Intel® Celeron® Processor in the 478-Pin Package

Specification Update

August 2003

Document Number: 290749-013

Figure 12. System Bus Reset and Configuration Timings

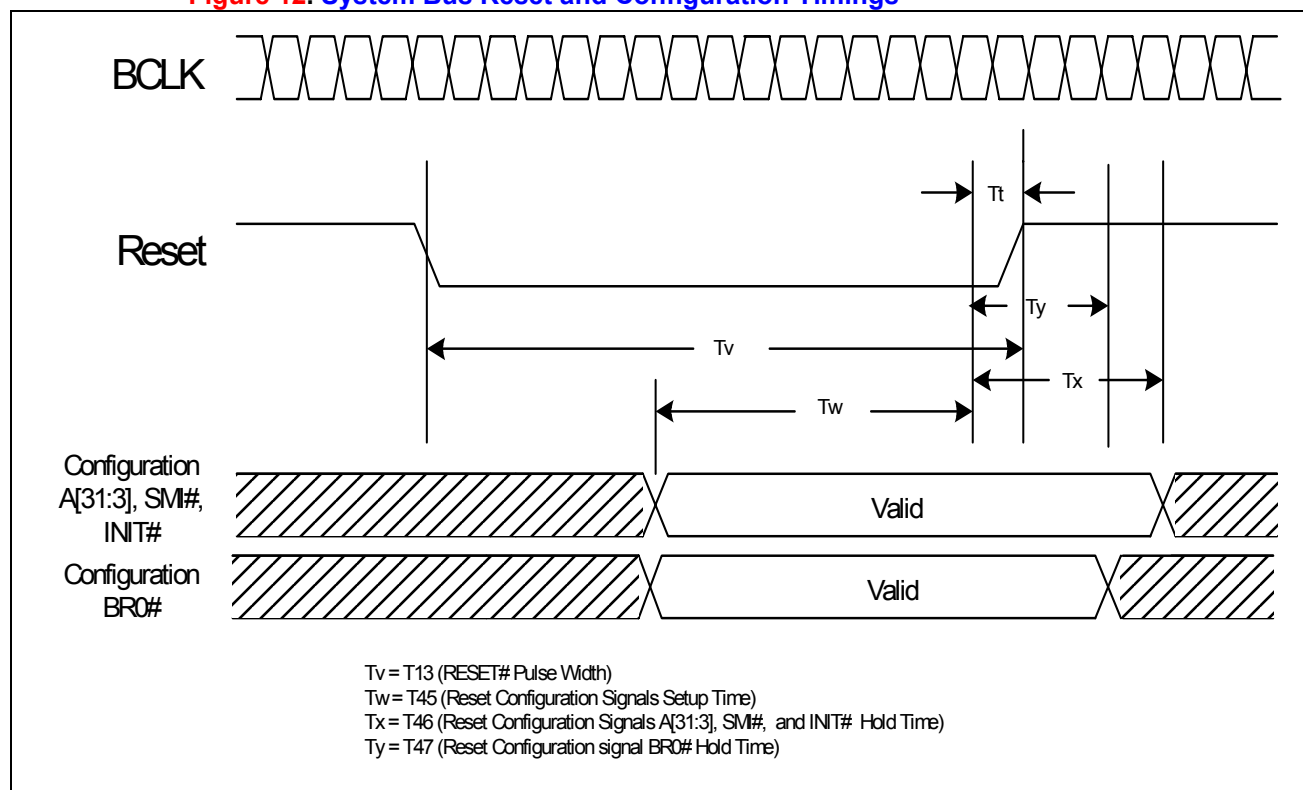
V1. BR0# Maximum Hold Time Specification Change

The BR0# maximum hold time has changed to 2 BCLKs. This change will be shown in the “System Bus AC Specifications (Reset Conditions)” table and “System Bus Reset and Configuration Timings” figure of the *Intel (R) Celeron (R) Processor on .13 Micron Process in 478-Pin Package Datasheet*. This change will be incorporated in the next revision of the Datasheet.

The following figure will be modified to reflect this change:

T# Parameter	Min	Max	Unit	Figure	Notes
T45: Reset Configuration Signals (A[31:3]#, BR0#INIT#, SMI#) Setup Time	4		BCLKs	12	1
T46: Reset Configuration Signals (A[31:3]#, INIT#, SMI#) Hold Time	2	20	BCLKs	12	2
T47: Reset Configuration Signal BR0# Hold Time	2	2	BCLKs	12	2
